REGULAR MEETING OF THE LAKE ORION PLANNING COMMISSION

Monday, February 5, 2024

TOPIC: PC-23-07 - Peninsula Site Plan Review

Please see the attached revised site plan documents addressing the review comments from Nowak and Fraus's review letter dated December 14, 2023, Orion Township Fire Department review letter dated December 18, 2023, and Mckenna review letter dated December 19, 2023 (responses are *italicized*):

TOPOGRAPHIC SURVEY / DEMOLITION PLAN

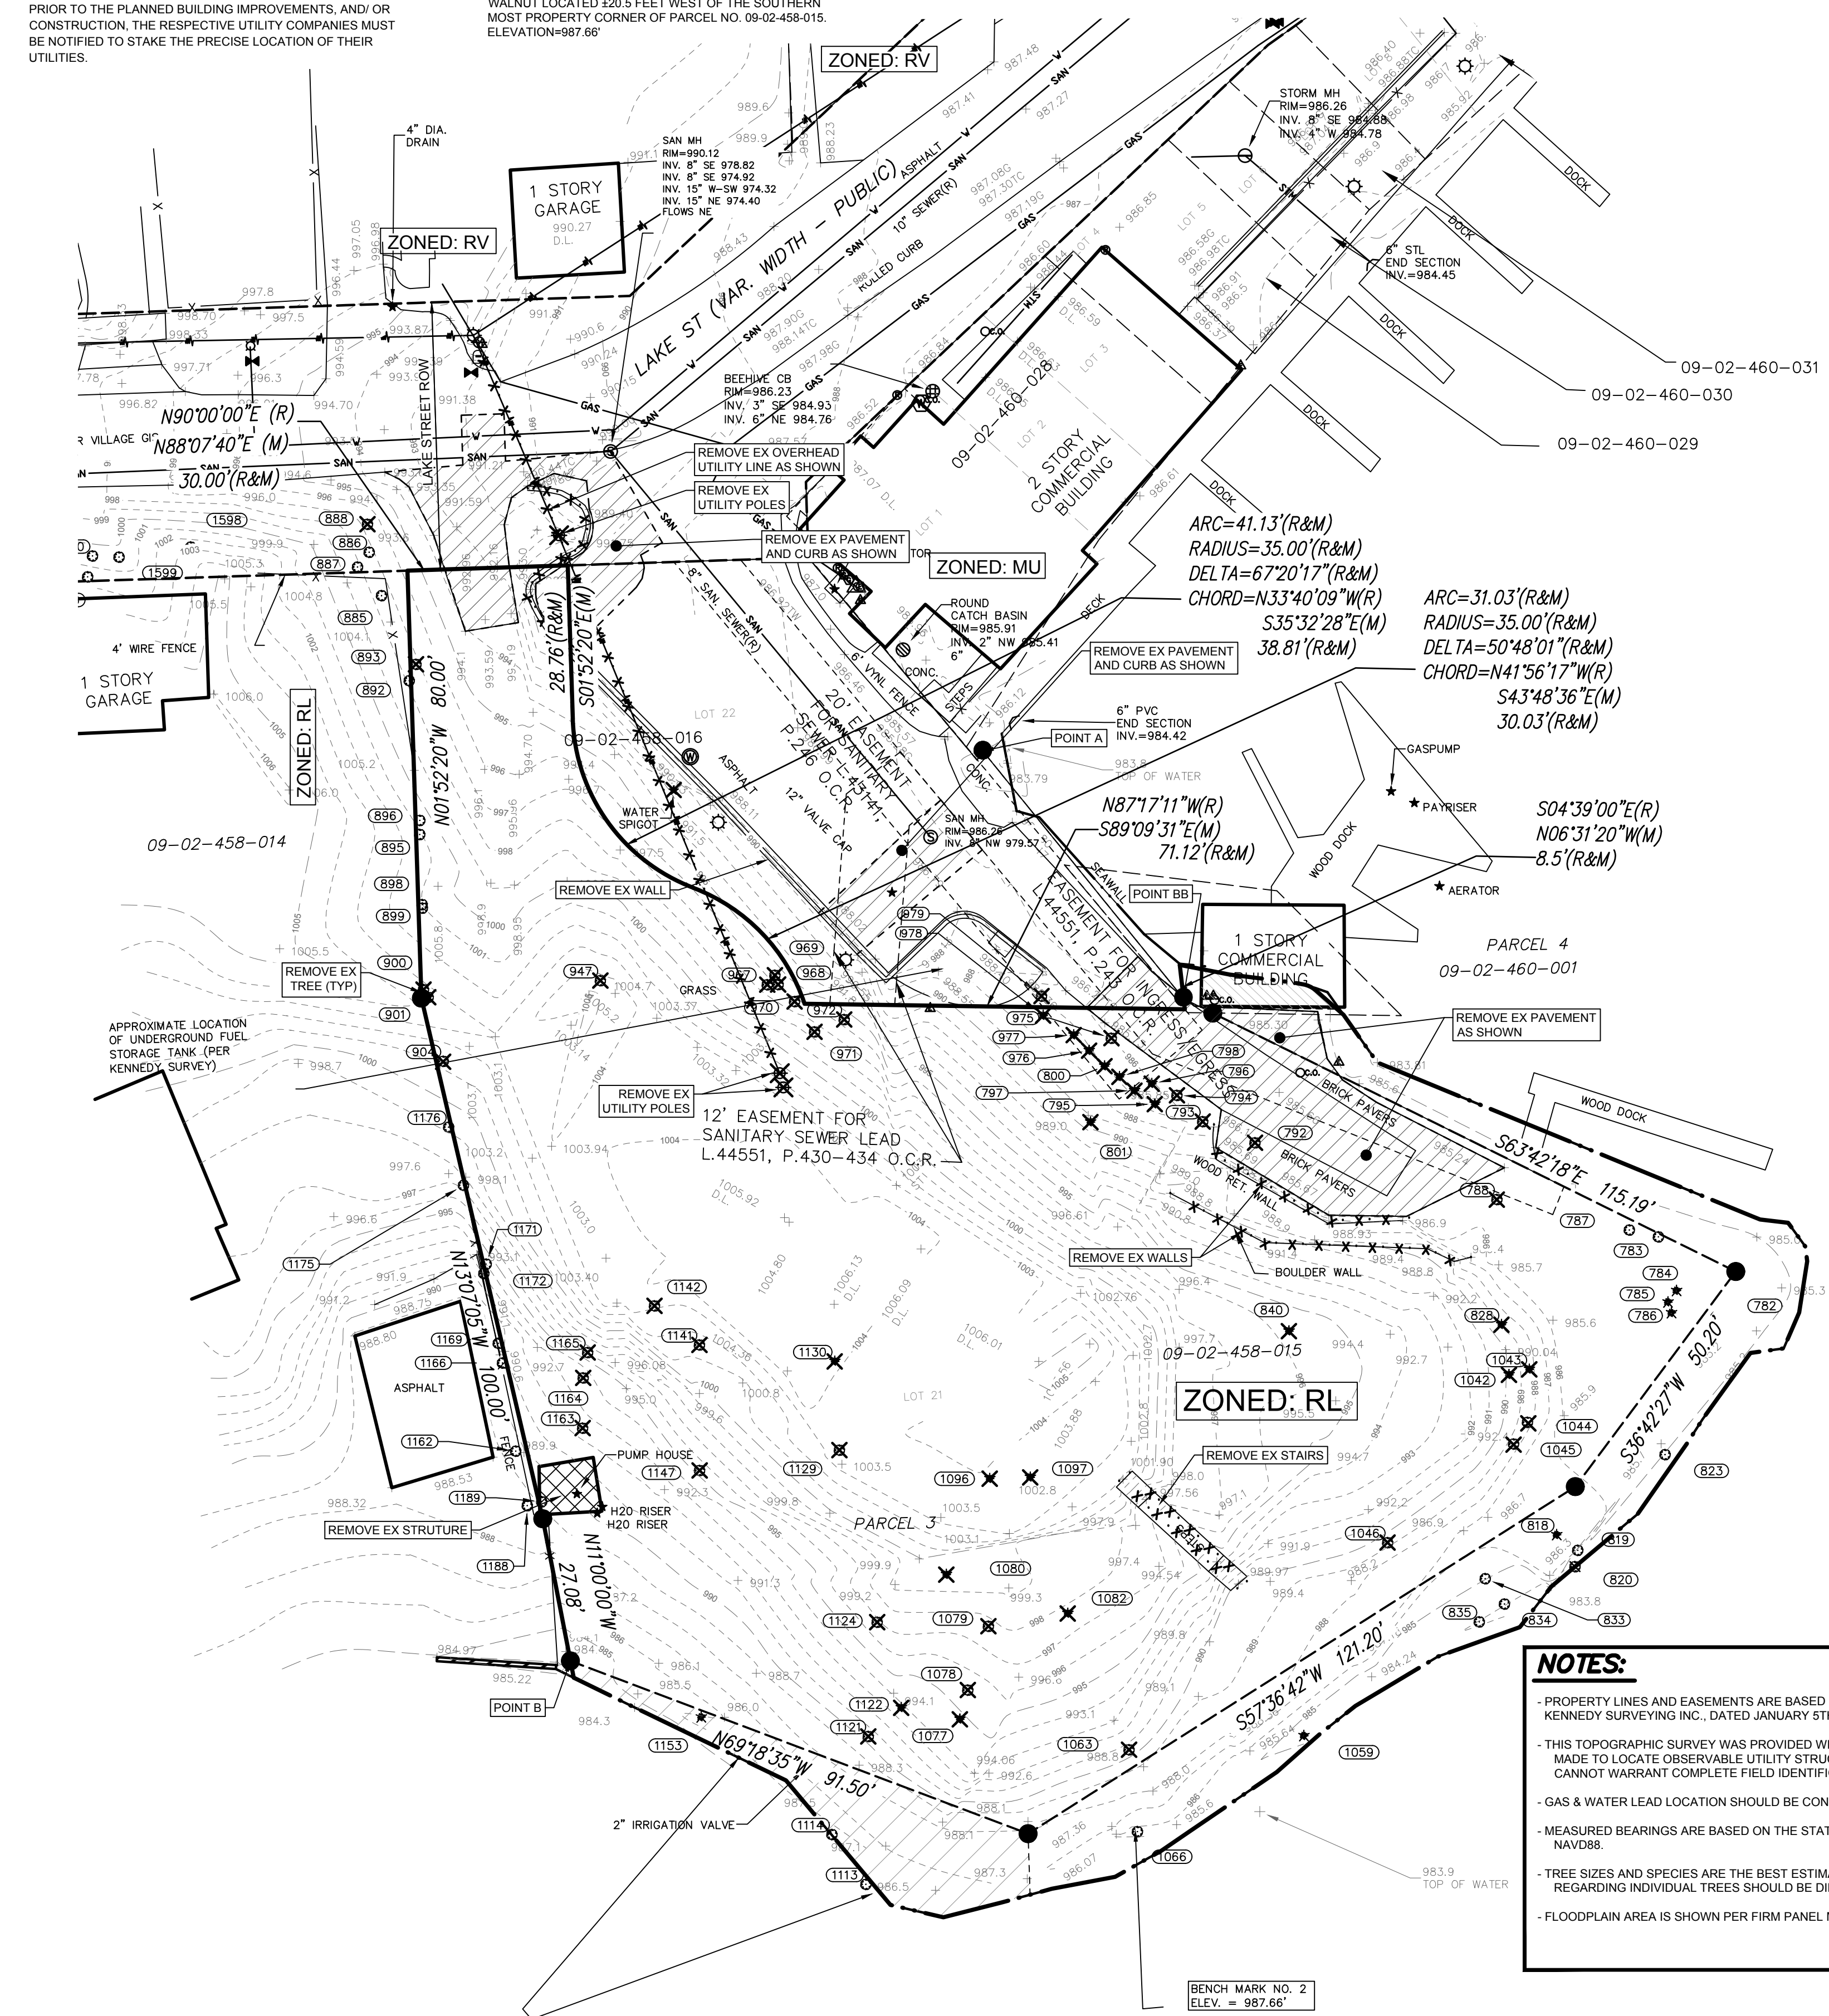
- The site location map (see Sheet 2) places this project where the reconfigured Starboard development is proposed.
Located map has been deleted.
- The graphic scale and written scale do not match on sheet 2. The graphic scale still reads 1" = 30', the actual scale is 1" = 20'.
Scale has been revised.

5. The graphic scale and written scale do not match on sheet 2.
6. Topography, including existing structures and their height, must be shown to 50’ outside the site boundary. It is shown to approximately 25’.

3. The site location map (see Sheet 2) places this project where the reconfigured Starboard development is proposed.
4. The graphic scale and written scale do not match on sheet 2. The graphic scale still reads 1" = 30', the actual scale is 1" = 20'.

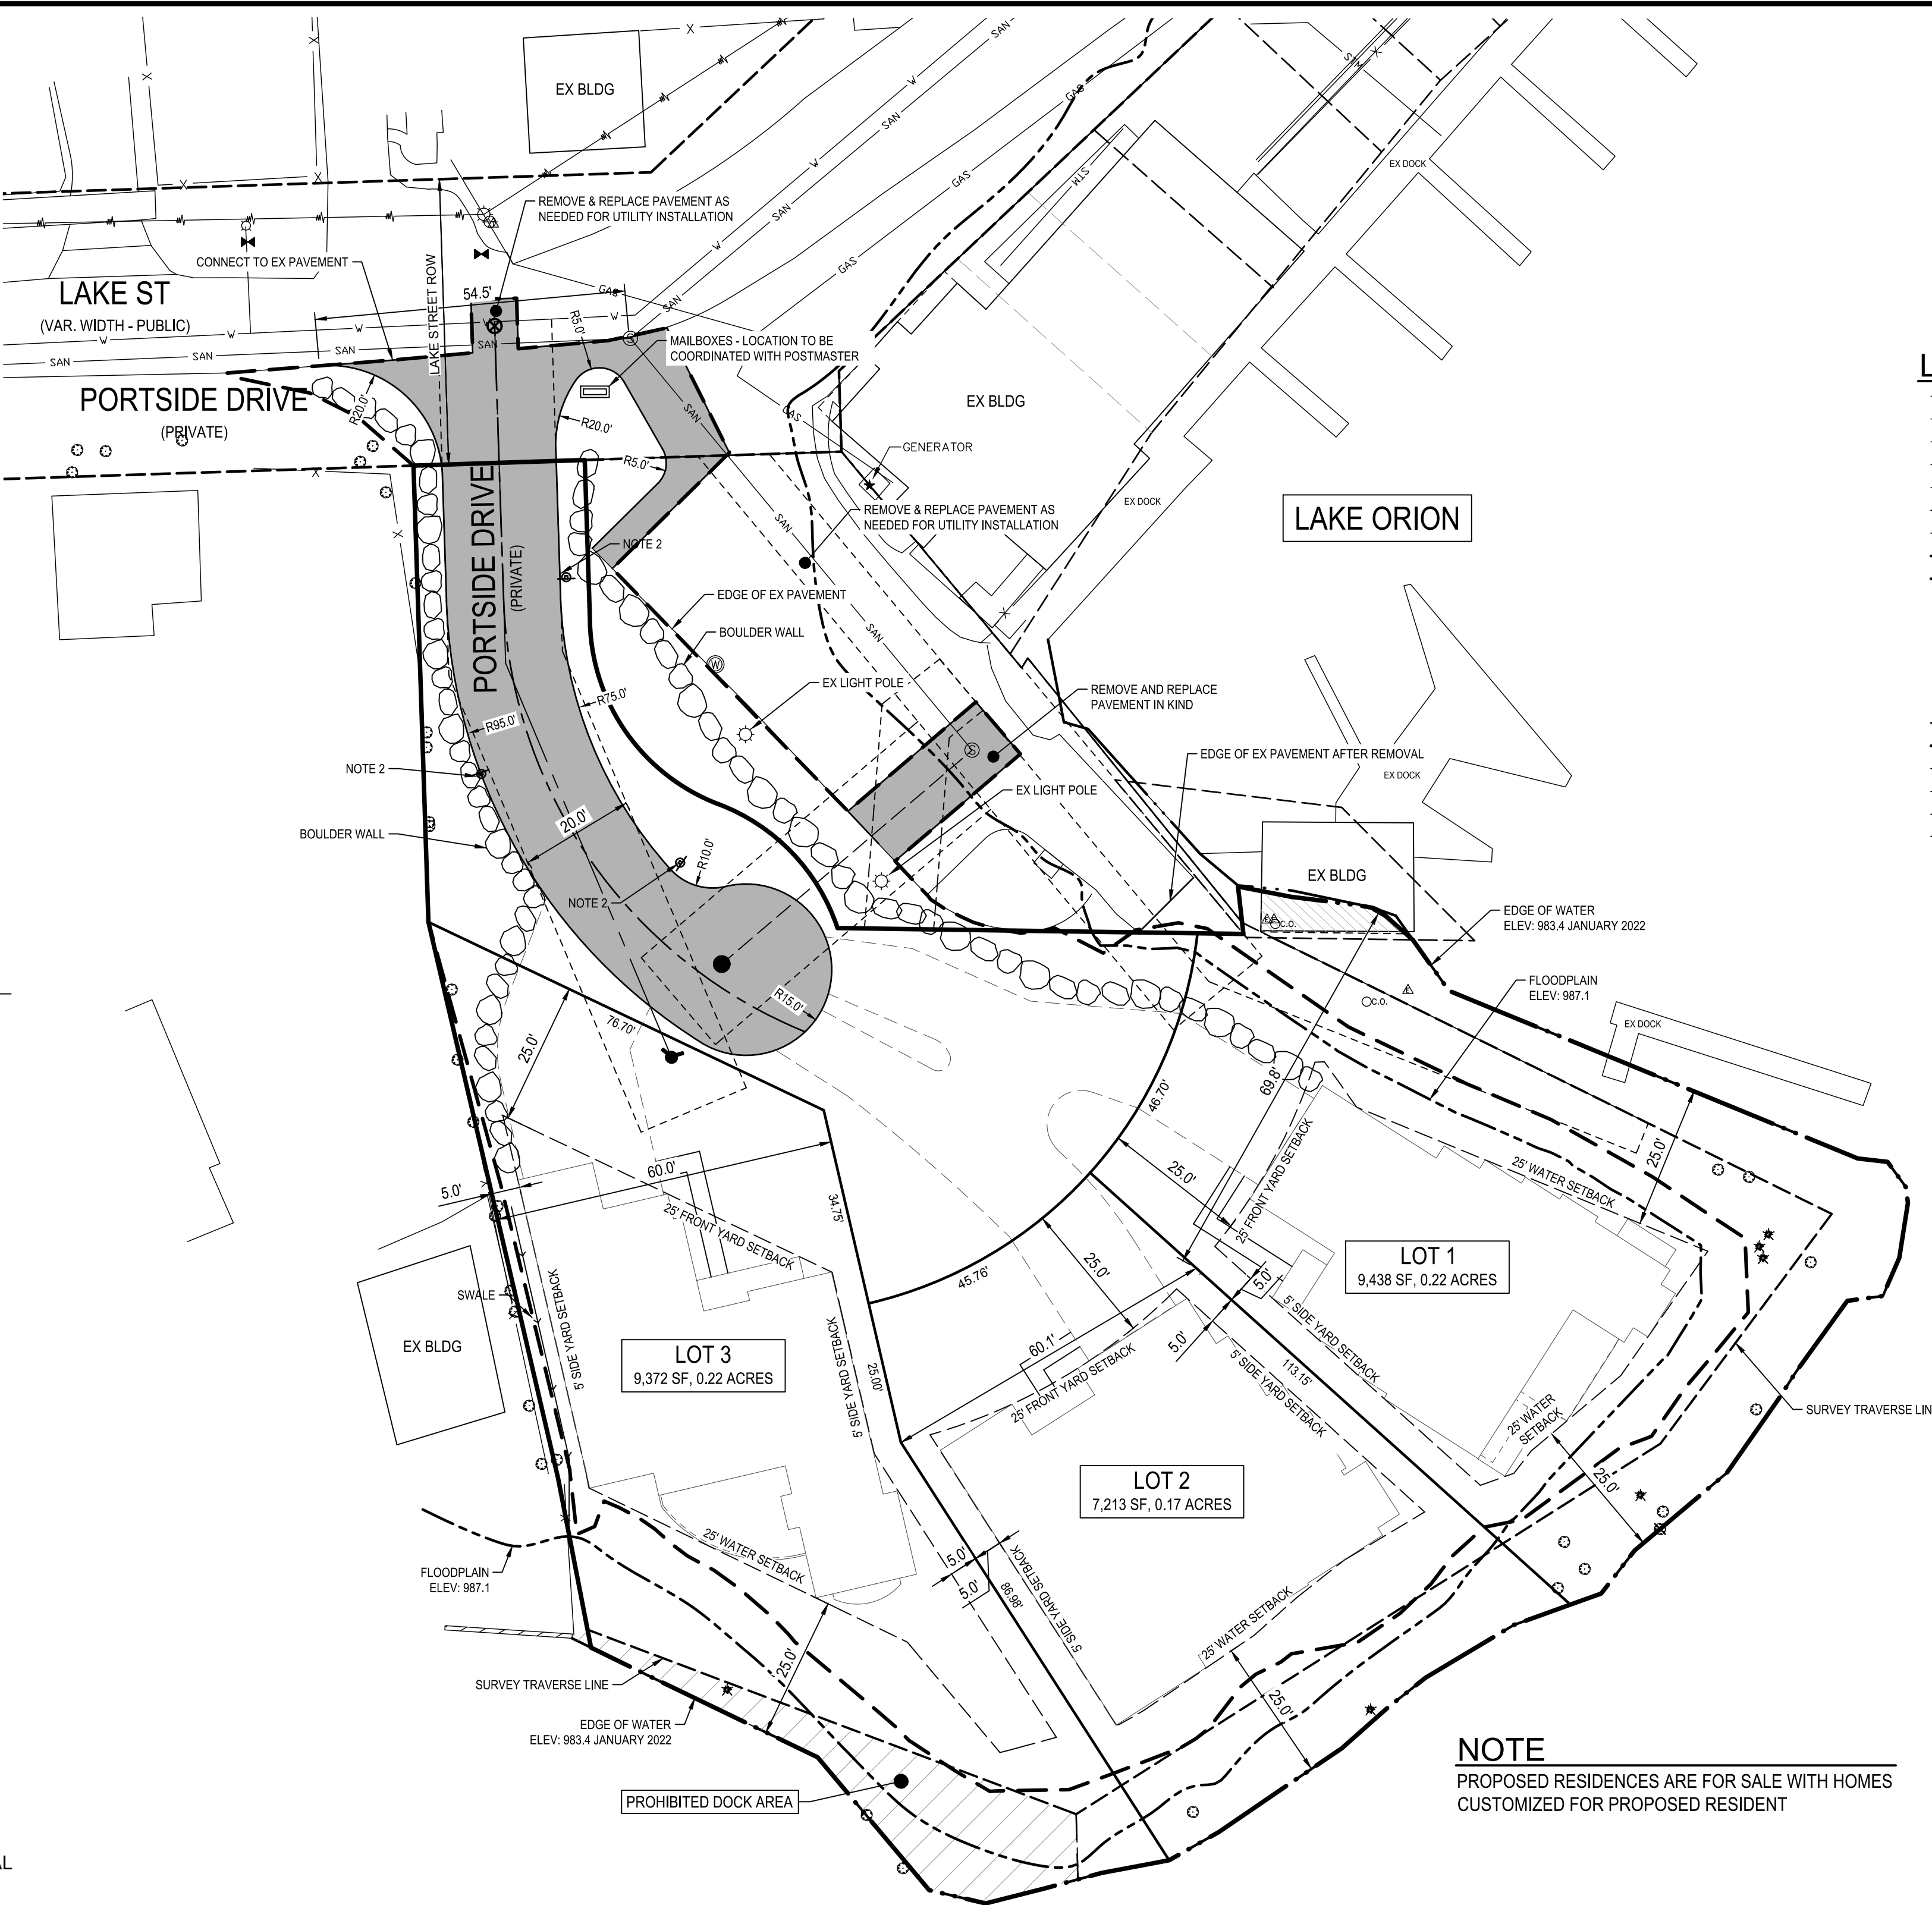
- Response letter states that right of way lines for Lake Street are shown; however, they are not labeled on any sheet. Also, Sheet 4 shows Portside Drive labeled in both the proposed private road and the public Lake Street right-of-way.
The ROW was labeled on both the topo and the site plan. Portside Drive label has been deleted.

5. Response letter states that right of way lines for Lake Street are shown; however, they are not labeled on any sheet. Also, Sheet 4 shows Portside Drive labeled in both the proposed private road and the public Lake Street right-of-way.

3. As stated in our last review, remove the “Portside Drive” label from the Lake Street right-of-way on sheet 4.
4. Applicant has stated that trees are being saved where possible and has provided a tree chart for Planning Commissioners’ information.

3. Fire department access roads 20 to 26 feet wide shall be posted with NO PARKING FIRE LANE signage on both sides of the fire apparatus access road. Details for the No PFL signage including road stripping (cross hatching) areas shall be indicated on the plan.
Signs are shown on Sheet 4.
